**Service Letter #:** SL08-35A-45065 Shear Bolt

**Part/Assembly #:** 35A-45000 3400 Main Gear, replacement of 35A-45050 Shear Pins with newly available 35A-45065 Shear Bolts.

**Float Model/Aircraft Affected:** Aerocet Model 3400 Amphibious Floats, Serial #330 and later, and any earlier floats in which cotter style shear pins have been replaced with the retaining ring style. (35A-45050, I/R is cotter pin style, while 35A-45050, Rev A is retaining ring style.)

**Figure 1 - Showing Main Landing Gear and 35A-45065 Pin Installation**

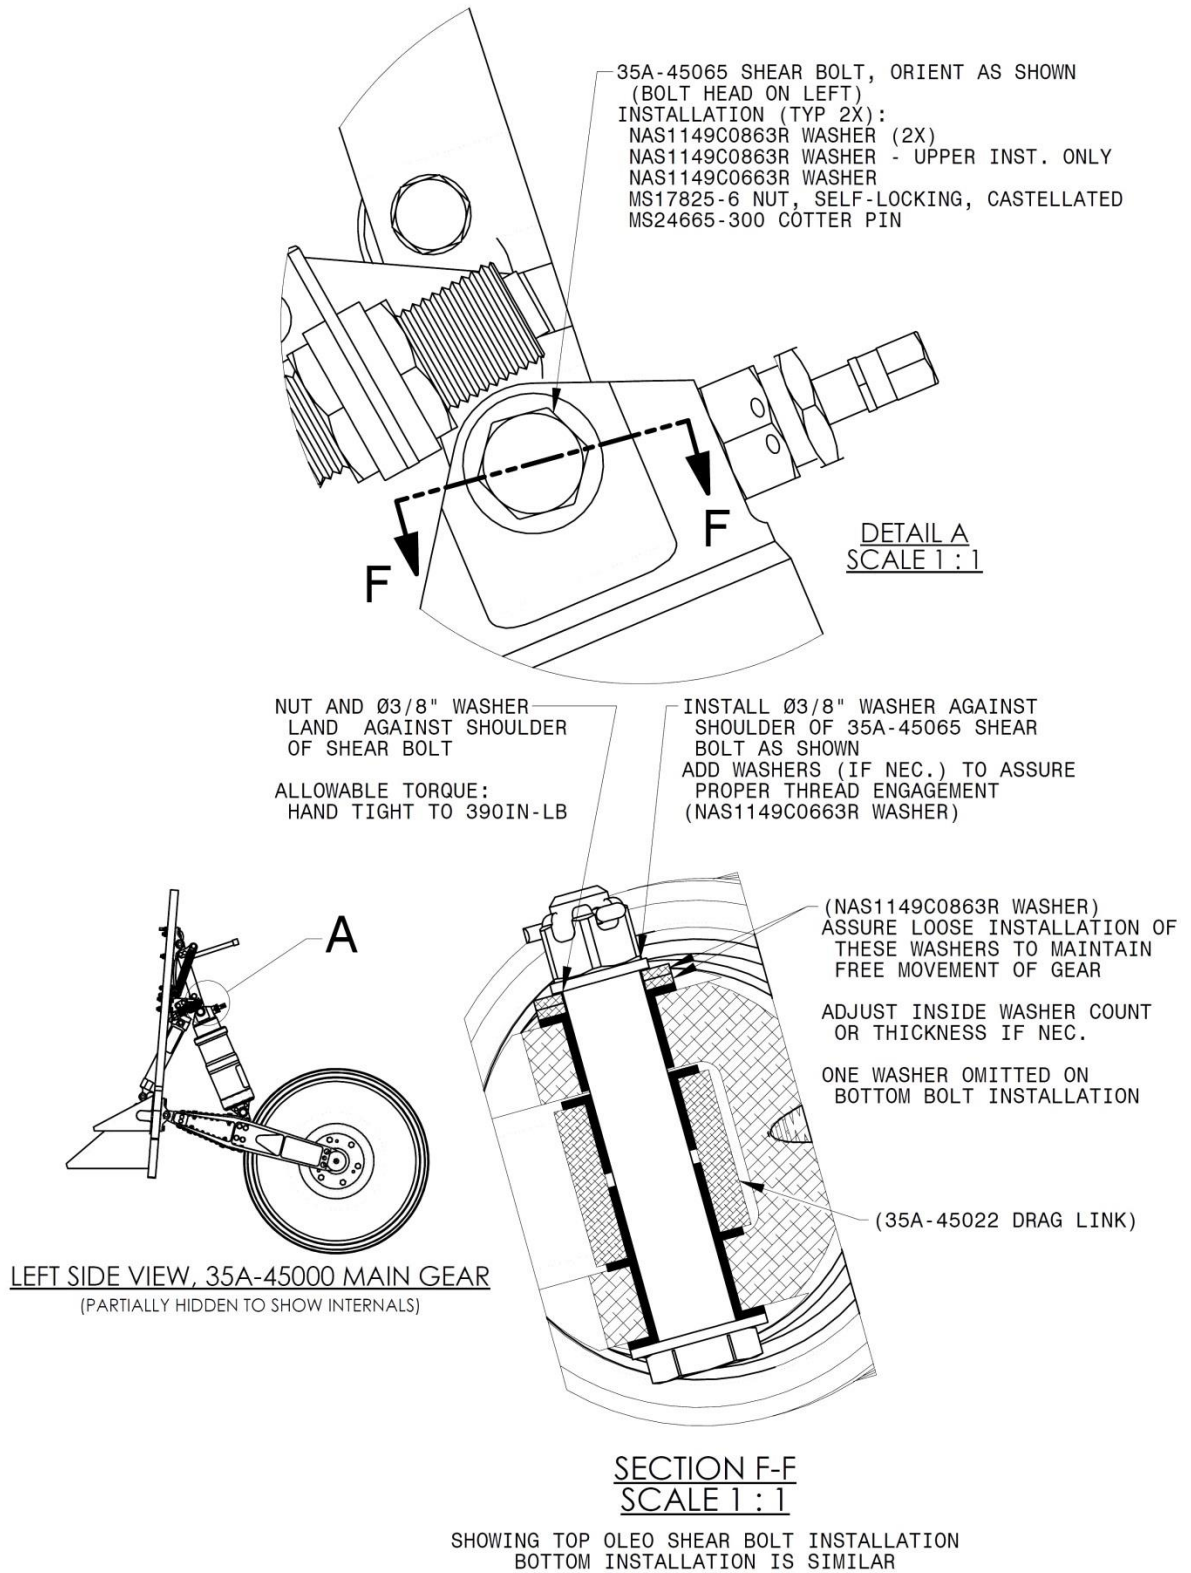
**Symptom:** MS16624-4050 Retaining Ring yielded due to over-spreading on installation.

It has been discovered that mechanics have overstretched the retaining rings that hold these pins in place upon either installation or removal of the shock strut reducing their retaining ability. As a result, retaining of the shock strut connecting pins may be lost.

Replace 35A-45050 Shear Pins with 35A-45065 Shear Bolts, as illustrated on following sheet.

- 1) 35A-45065 Shear Bolt (4X)
- 2) NAS1149C0863R WASHER (10X)
- 3) NAS1149C0663 WASHER (4X)
- 4) MS17825-6 NUT, SELF-LOCKING, CASTELLATED (4X)
- 5) MS24665-300 COTTER PIN (4X)
